Technical Service Bulletin

69 Noises from front seat belt buckle/seat cover

69 22 76 2065720/1 January 8, 2022.

Model(s)	Year	VIN Range	Vehicle-Specific Equipment
A3, A3 Cabriolet, and S3	2015 – 2016	All	Not Applicable

Figure 1. Felt mat 8V0 858 541 attached to belt buckle.

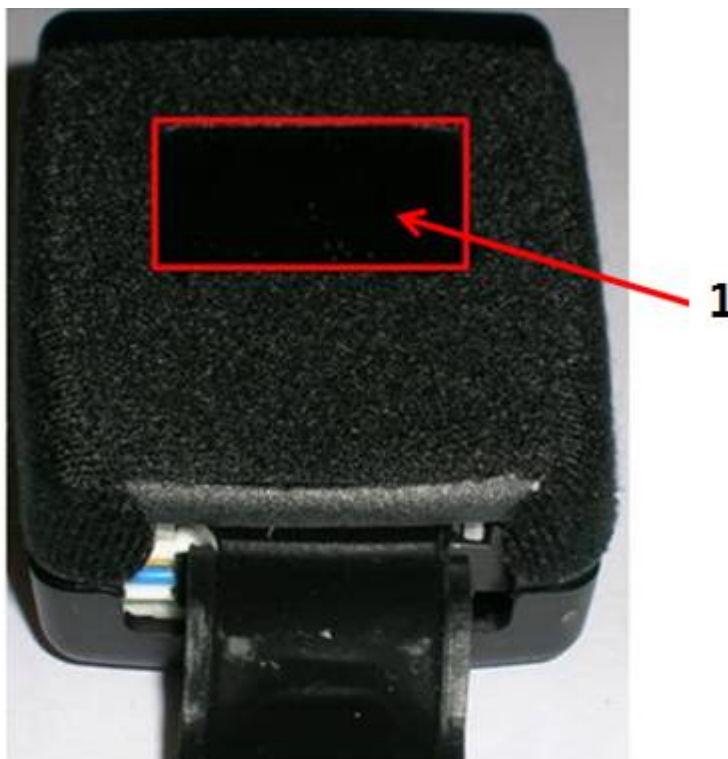
In some instances, depending on the position of the driver's or front passenger side seat, noises can be generated between the belt buckle and the seat cover.

- Attach a felt mat with part number 8V0 858 541 to both front belt buckles (Figure 1).

2. When attaching the felt mat, it is essential to ensure that the text field in the center of the belt buckle stays uncovered and the lower edges are covered with the felt (Figure 1).
